WASHINGTON COUNTY, OREGON

RE: **Sunset Gardens Multi-Family**
City File Number: **DR2016-0032/LD2016-0005/TP2016-0005**
Tax Map and Lot Number: **1S1-05 CB 100, 200, 300, 400, 1800, & 1900**
Location: **SW 158th Avenue/W. Baseline Road**

RE: Sunset Gardens—Request for Access Spacing Design Exception
CDA #: N/A (Through City of Beaverton)

Re: **Sunset Gardens – Request for Access Spacing Design Exception**
Project Number 2140343.01

MGA 1

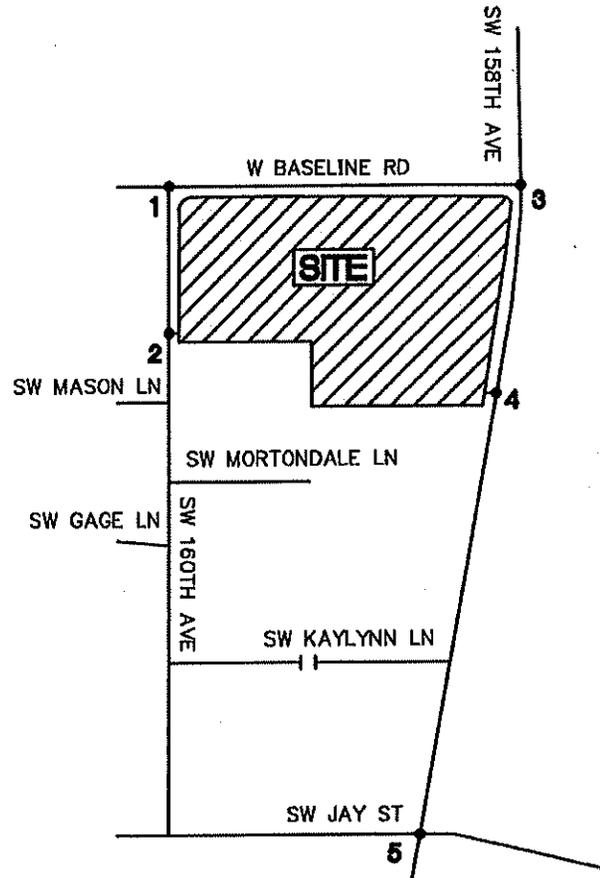
This design exception is only relevant to the Sunset Gardens development and attached site plan (See sheet MGA 1). This design exception is non-transferrable.

X Your request is approved as proposed.
